### **Addendum 25 – UN Regulation No. 26**

#### **Revision 1 - Amendment 3**

04 series of amendments – Date of entry into force: 25 September 2020

### **Uniform provisions concerning the approval of vehicles with regard to their external projections**

Figure 0  
Example of parts distribution

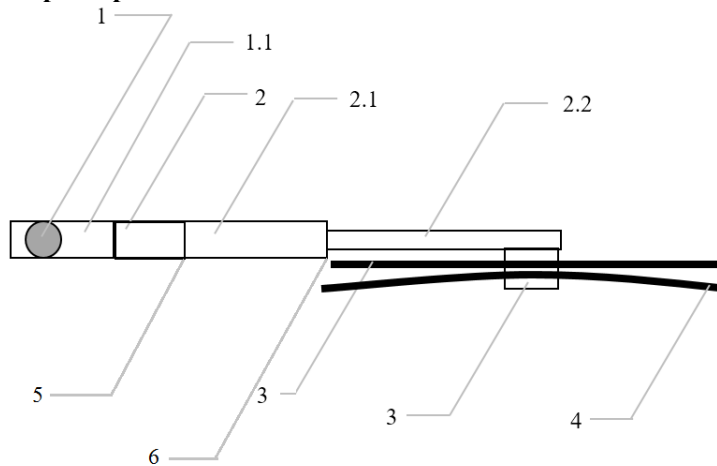
Paragraphs 6.4. to 6.4.2., amend to read:

- "6.4. Windscreen wipers
- 6.4.1. The windscreen wiper fittings shall be such that the wiper shaft (number 1 in Figure 0) is furnished with a protective casing (number 1.1 in Figure 0) which has a radius of curvature meeting the requirements of paragraph 5.4. above and an end surface area of not less than 150 mm<sup>2</sup>. The holder (head and main part, i.e. numbers 2, 2.1 in Figure 0) are designed with a radius of curvature meeting the requirements of paragraph 5.4. above. In the case of rounded covers, these shall have a minimum projected area of 150 mm<sup>2</sup> when measured not more than 6.5 mm from the point projecting furthest. These requirements shall also be met by rear window wipers and headlamp wipers.

- 6.4.2. Paragraph 5.4. shall not apply to the wiper blades (number 4 in Figure 0), supporting members (number 3 in Figure 0) if present, to second holder (number 2.2 in Figure 0) if present, to the functional hinge between the holder head and the holder (number 5 in Figure 0) if present, or to the junction between the main and the second holder (number 6 in Figure 0) if present. However, these units shall be so made as to have no sharp angles or pointed or cutting parts.

Model A

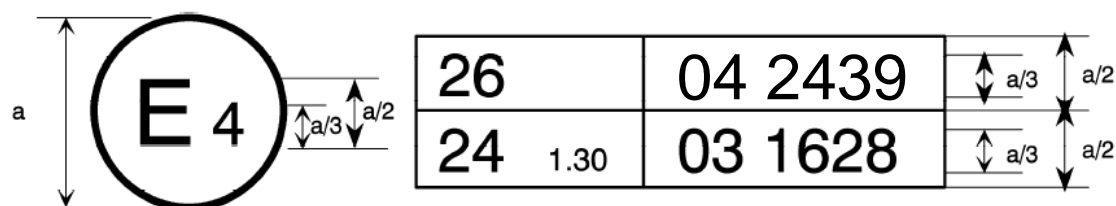
Annex 2, amend to read

The above approval mark affixed to a vehicle shows that the vehicle type concerned has been approved in the Netherlands (E 4) pursuant to UN Regulation No. 26 and under approval number 032439. The first two digits of the approval number indicate that UN Regulation No. 26 already included the 04 series of amendments when the approval was granted.
